Origination Form Proposed Revisions to a Standard Plans Index

Originator:	Stepp, Richard	Index Number:	635-005
Date:	7/10/2024	Sheet Number(s):	All
E-mail:	richard.stepp@dot.state.fl.us	Index Title:	Fiber Optic Splice Vault

FIBER OPTIC SPLICE VAULT

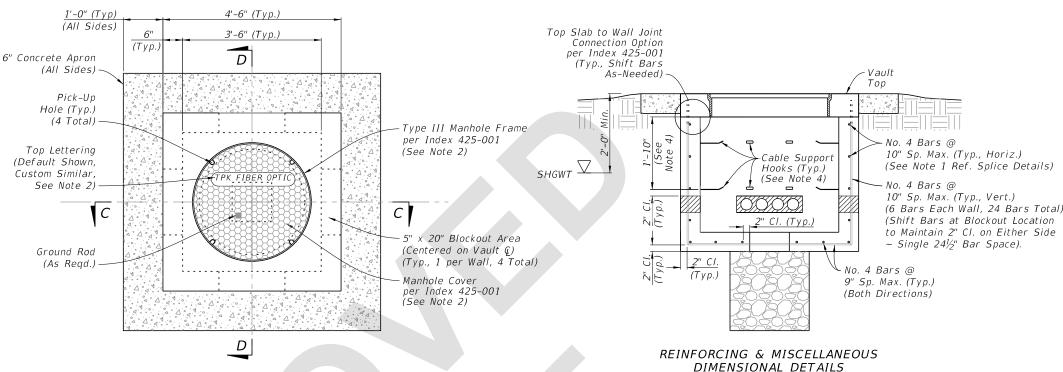
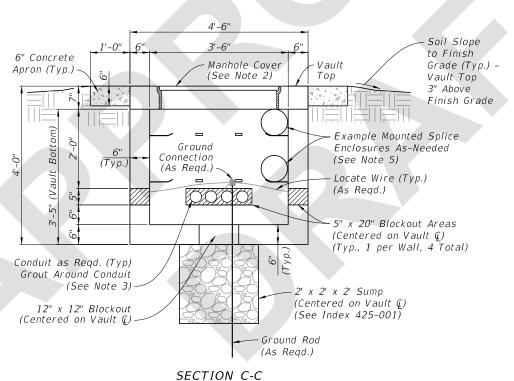
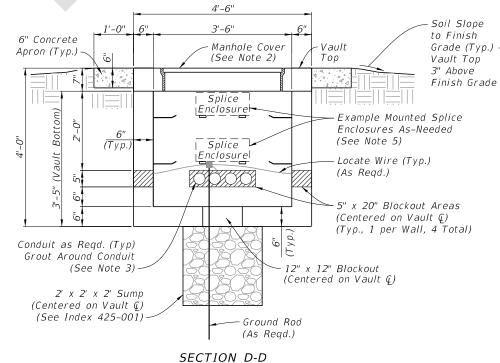
Publishing all-new Standard Plans Index

This Index was previously published as Developmental Standard Plans. This Fiber Optic Splice Vault was developed in coordination with the Florida Turnpike Enterprise to help accommodate recurring ITS infrastructure needs. This Index works with the newly revised versions of Standard Specifications 635 and 996.
